NEW ADDITION TO GOSHEN MENNONITE CHURCH

8410 BRINK RD., LAYTONSVILLE, MD 20882

HISTORIC PRESERVATION COMMISSION STAFF REPORT

PROPOSAL: Rear and Side Addition

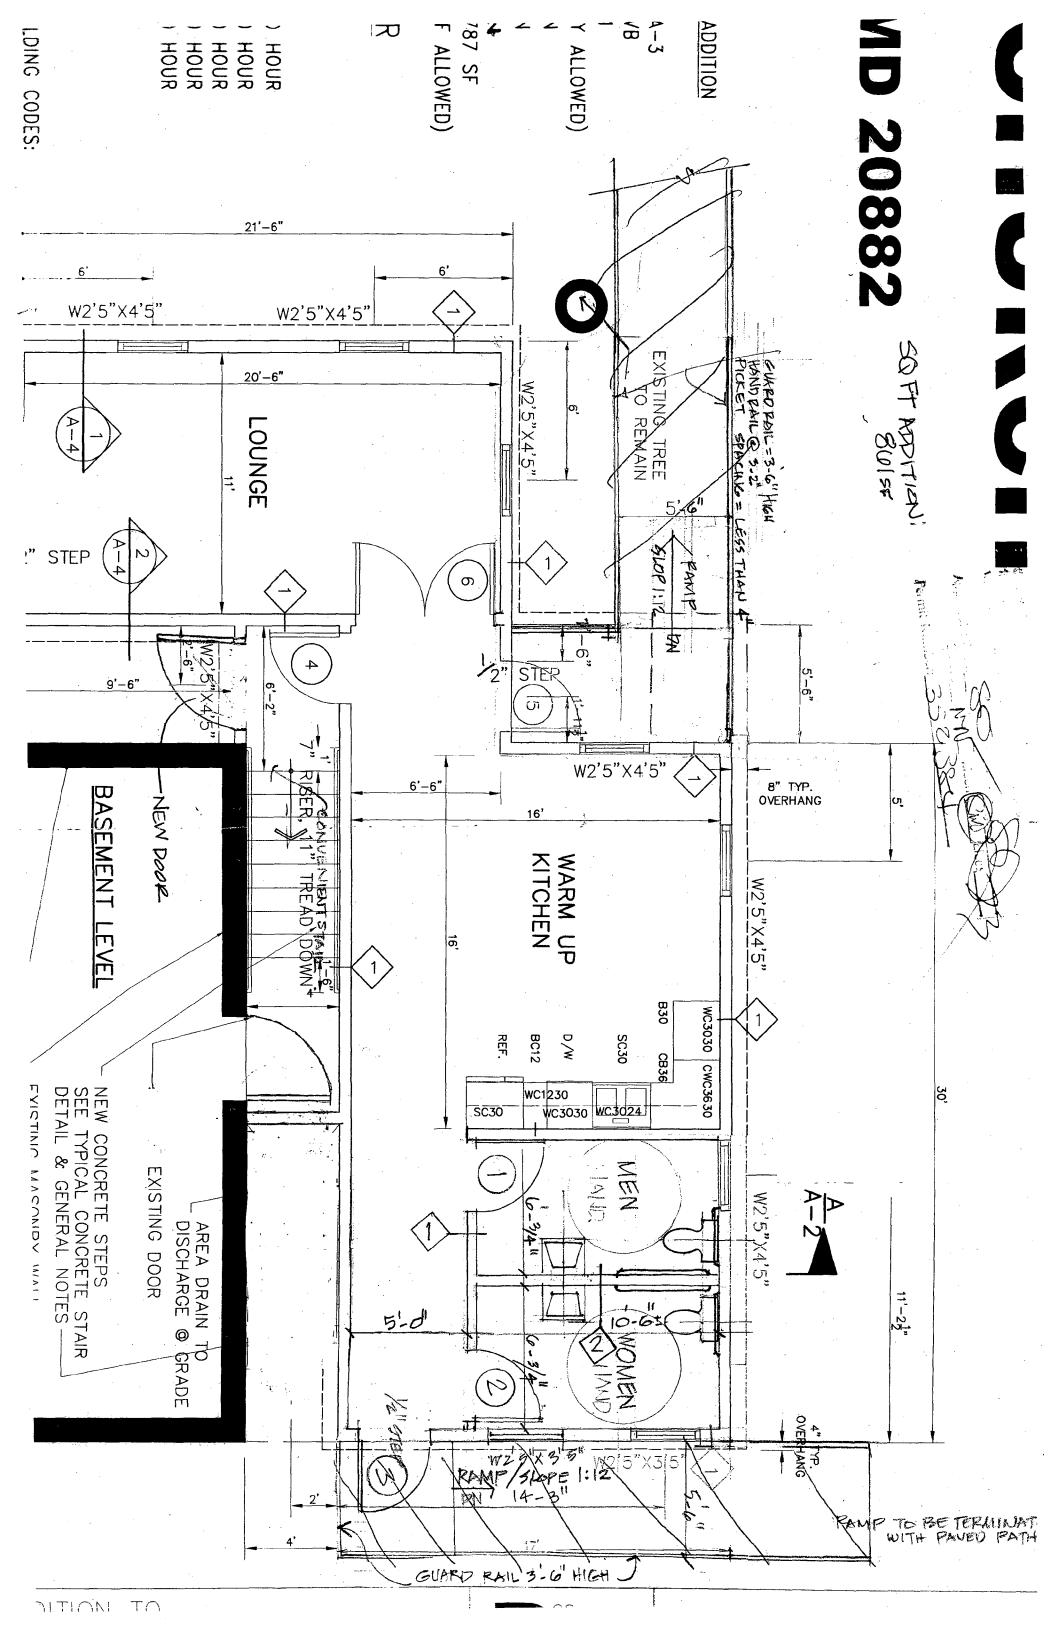
Stacey Dyer - Plan reriewer ramp reguirements Hadi Marsouri - gour approval for med of Doors as per the attached dues. Sharahan. 258 +603 \$(8U) underprining-Southeral <50 - DO NOT GO NEED EXIT. Heat May refuse - 10/1 hr needs a modification. - brick/stone W New year doon = - brick wells ist ing Rating Certify presented wall. Glarrier assembly - architect needs to make into 2 sep - Reperation blues 2 uses uce - existing-assembly addition - Business mercautilines - Laccessible manp

seperated muxed-use - seperated mix-use - torne for a revision - 90 back to organism for bathyoms

Goshen Church Restrooms

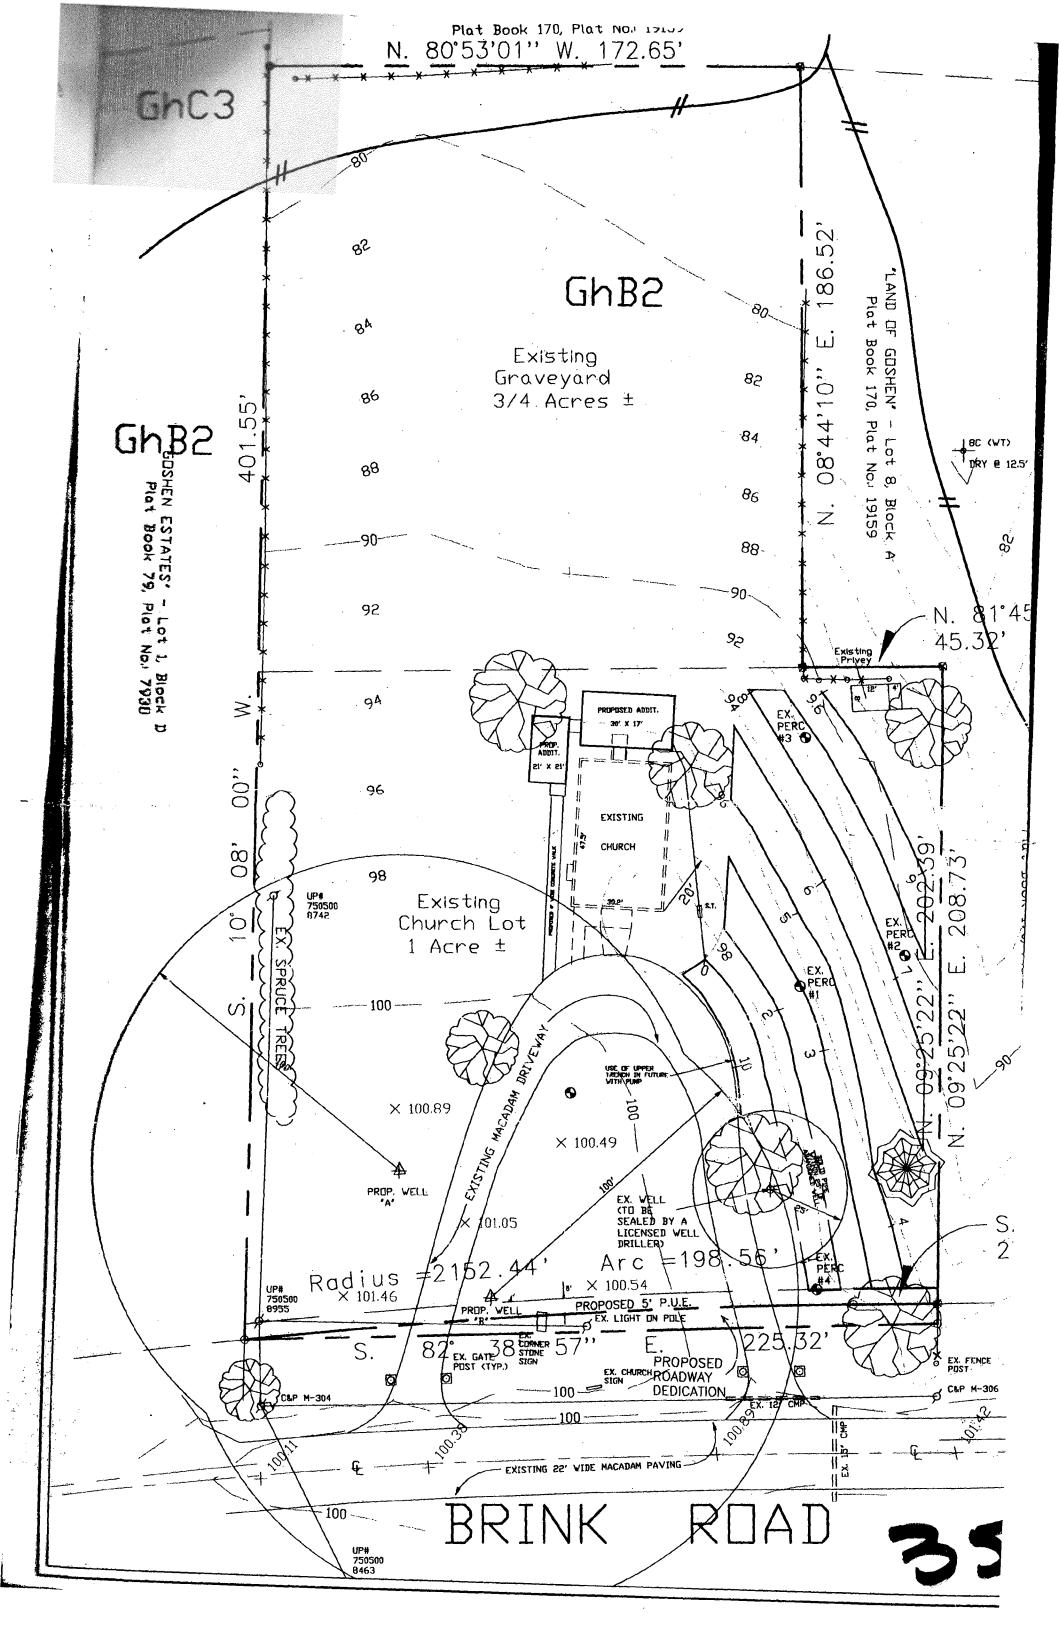
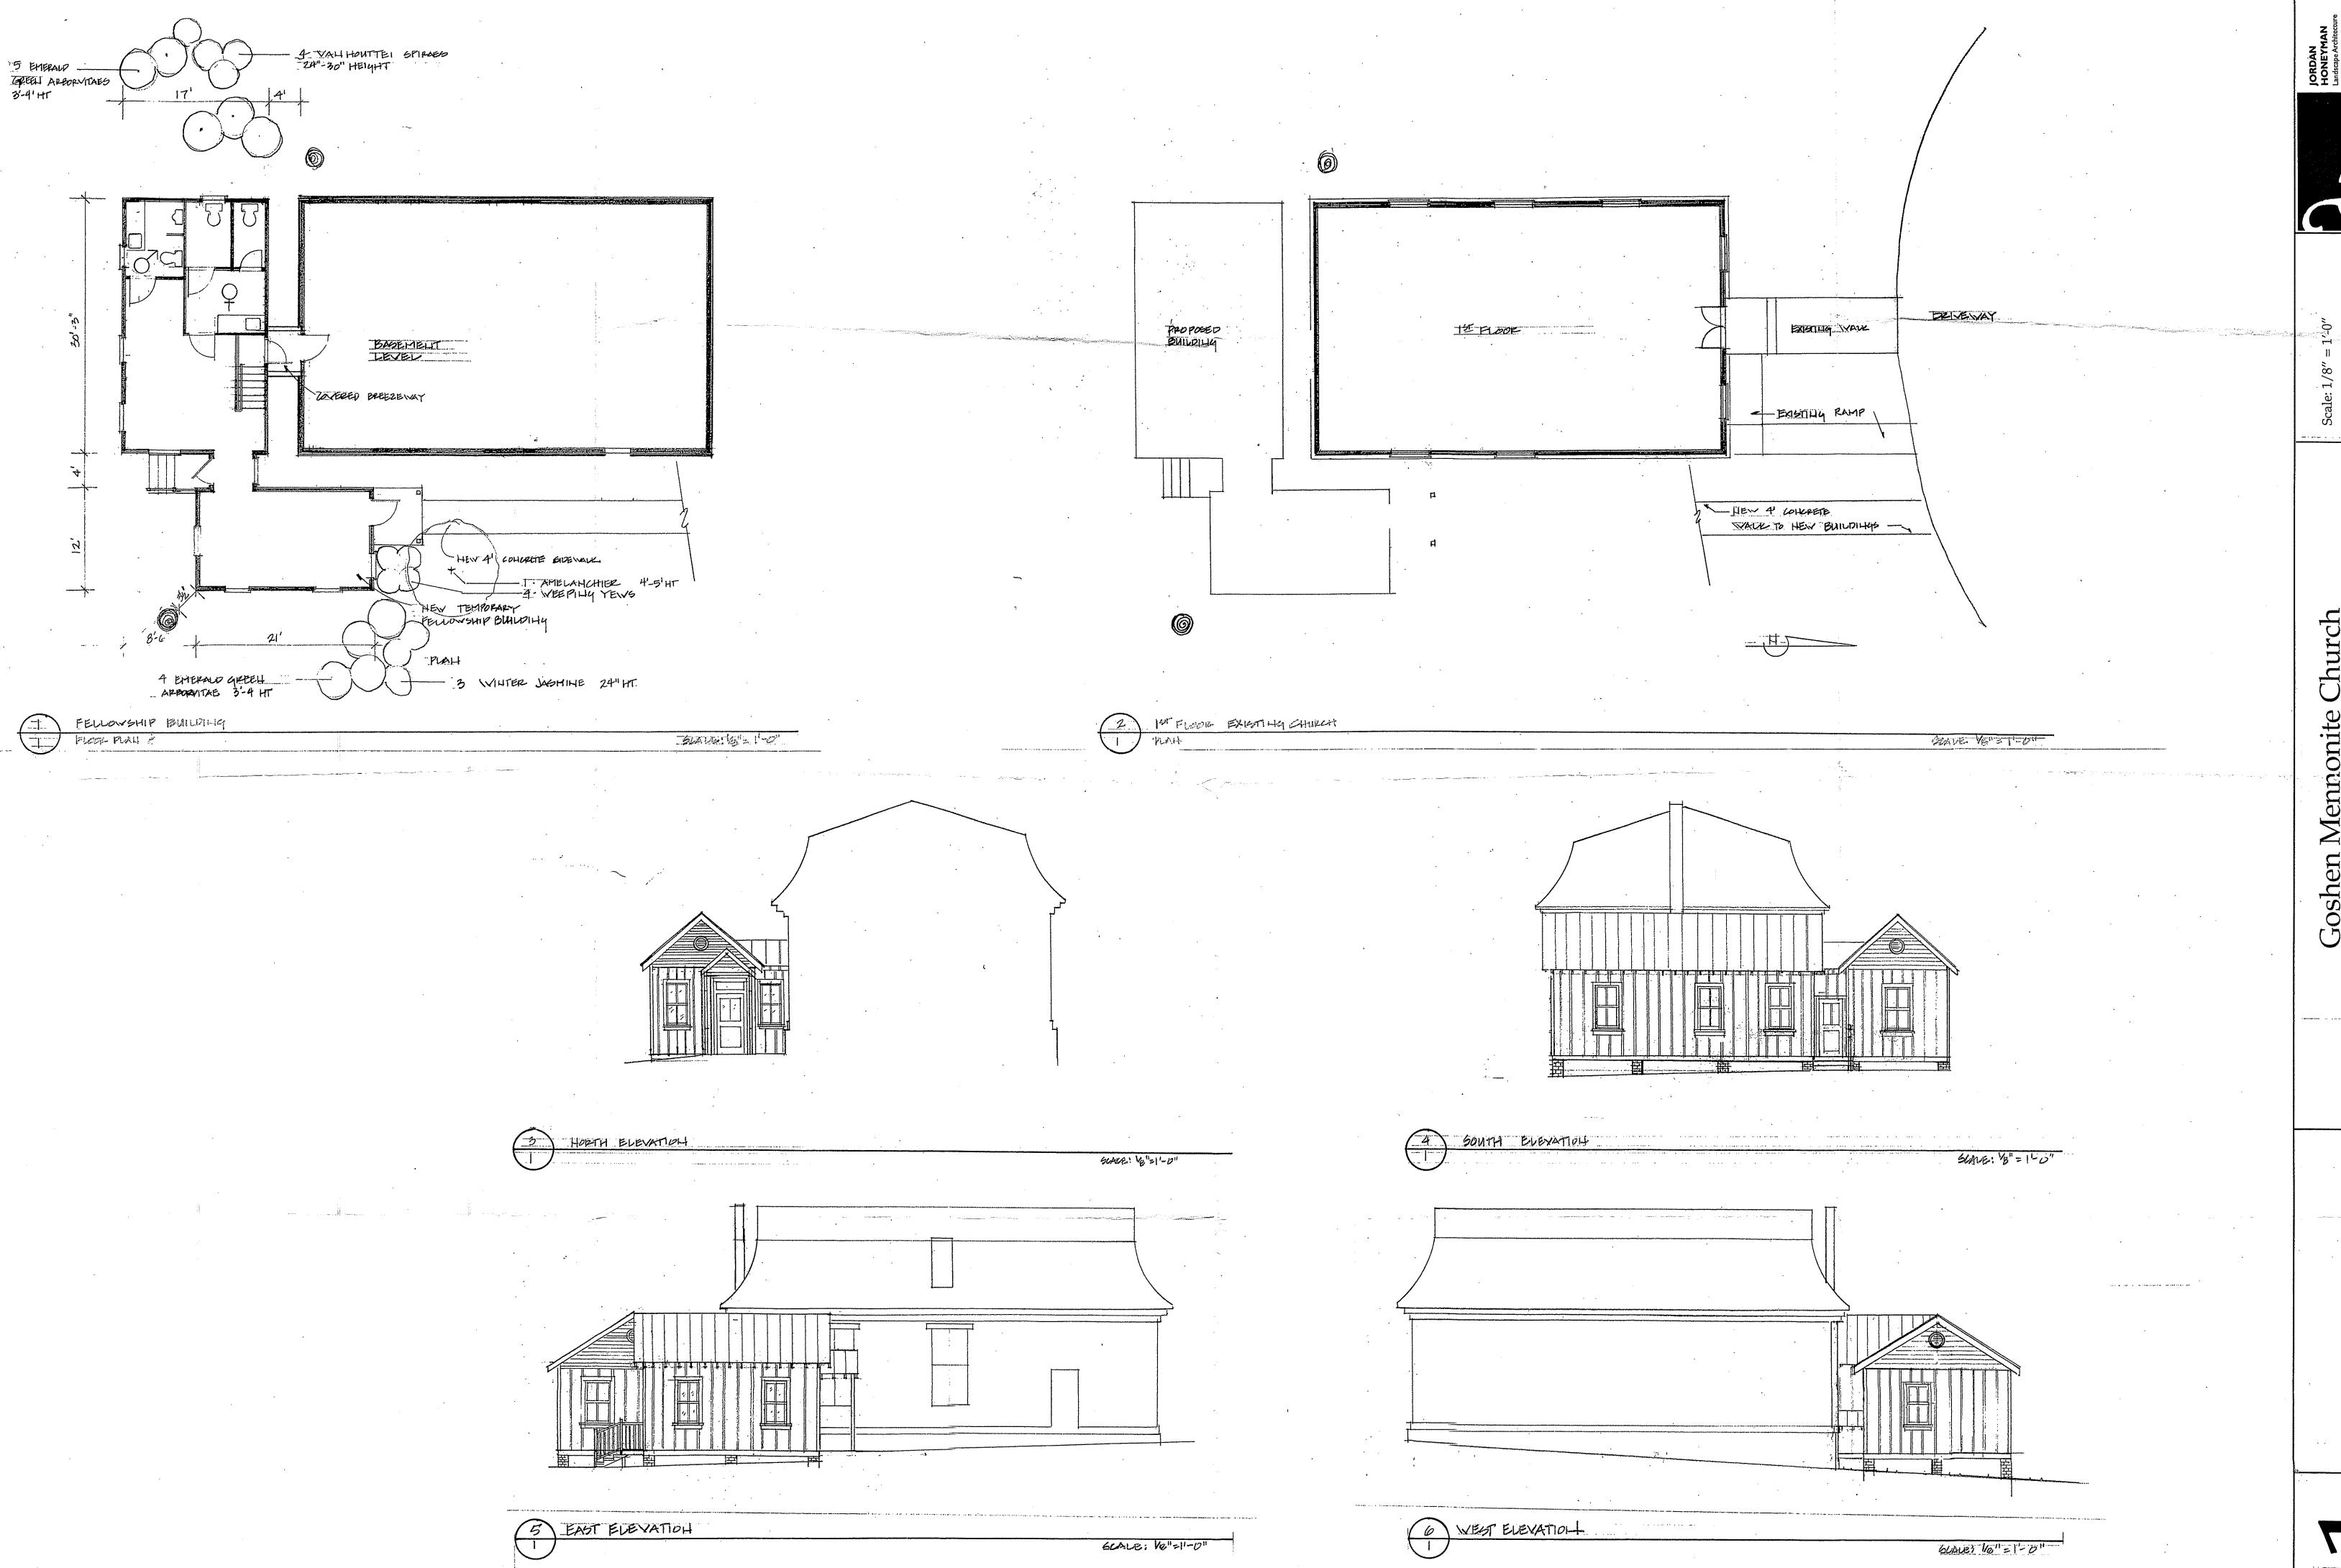
The area in the circle is the change. The roof would slope with the steps, on post next to the building. This way we can have the door at floor level instead of half way. This way the framing will work out for sitting the building on piers as planed. And also if the buildings are taken away the steps will be next to the church not four foot away.

This is in-Keeping of HPK HAWP approval. I doscursed that with applicant 12/99 - and

They should still be coming to us to stamp There drawings before gory to DPS. 107
